Wiltshire Council Planning Consultation Response

URBAN DESIGN

Application No: PL-2026-04365

Site Address: Co-operative Food, Mill Street, Calne, SN11 0HT

Possible approaches to the roof design. Changing the direction of the roof pitches can also help create a more dynamic and memorable design which would be beneficial when approaching from the Riverside.

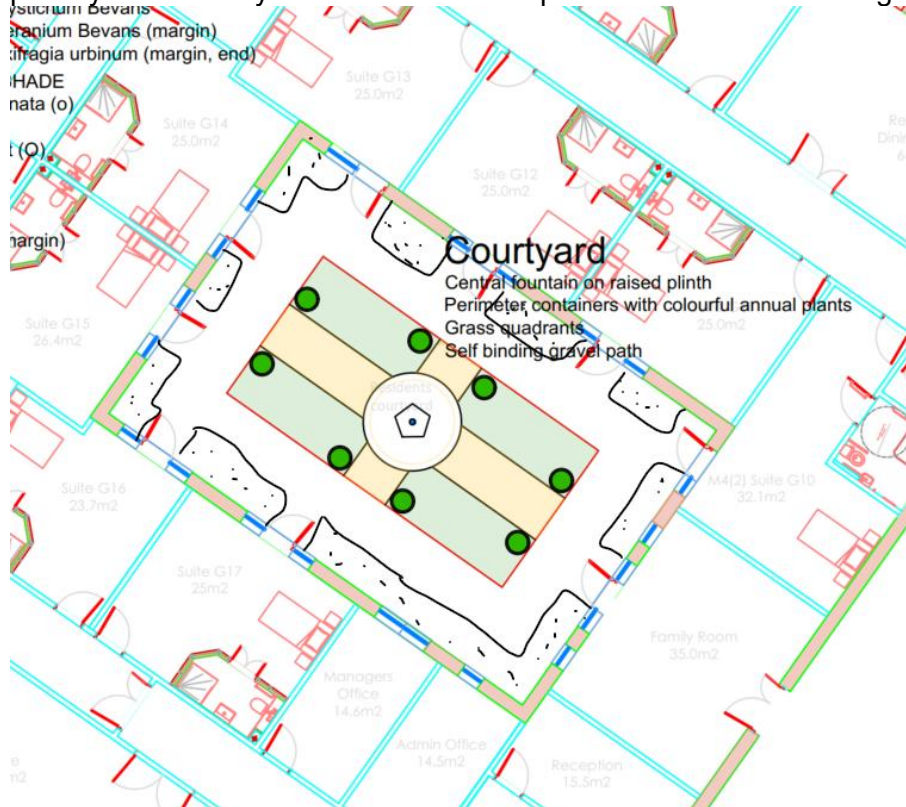
Recommendation: Consideration should be given to introducing additional roofscape articulation to the river-facing elevation, potentially using pitched gables or other elements that create a looser and more informal composition. This would help establish a more distinctive riverside identity, improve legibility, strengthen the relationship with the River Marden and provide a clearer

distinction between the principal street frontage and rear elevation. It is important that any gables form a genuine component of the building's massing rather than appearing as applied decorative elements. As identified at pre-application stage, there is a risk that superficially applied features can create a 'stage-set' appearance, where articulation is perceived as cosmetic rather than an authentic expression of the building's form. Any proposed gables should therefore contribute meaningfully to breaking down the massing and enhancing the overall composition of the roofscape, as can be seen in the precedent imagery.

*Flats are used to turn the corner of this urban block. Stepped bay windows and a large chimney stack to create a positive and interesting facade treatment on a prominent corner. **Pottergate, Alnwick, Northumberland***

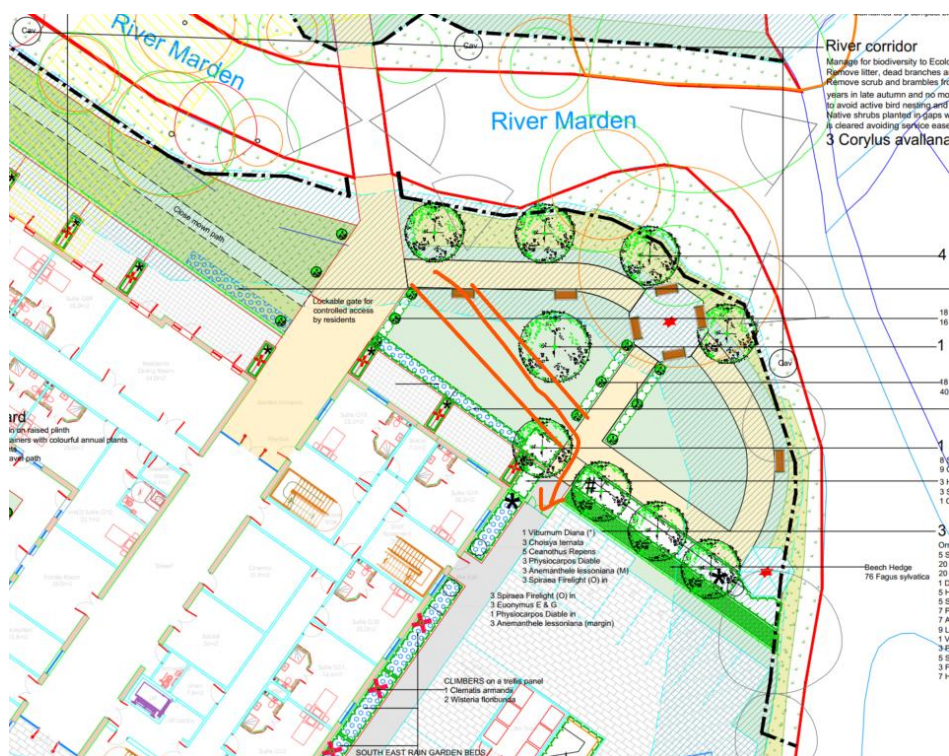
In addition, the treatment of the corner is not considered successful. The prominence of the bin store at this location creates an inactive frontage and results in servicing infrastructure occupying a visually important position within the streetscape. Corner plots play a significant role in defining views, assisting wayfinding and creating positive transitions between streets, and therefore warrant a higher quality architectural response.

Recommendation: The alignment of the eastern terrace should be reviewed with a view to bringing it into alignment with the western terrace and reinforcing a stronger, more coherent street frontage. Consideration should also be given to relocating the bin store and strengthening the architectural treatment of the corner to provide a more active frontage and improve the quality of the public realm. This would better reflect the linear development pattern and continuity of frontage identified within the Calne Design Guidelines and Codes.

As noted previously there is an opportunity to create a key corner with this gable which would be experienced sequentially when approach from the Pippin. The National Design Guide places importance on turning the corner and there is an example of how this can be achieved below.
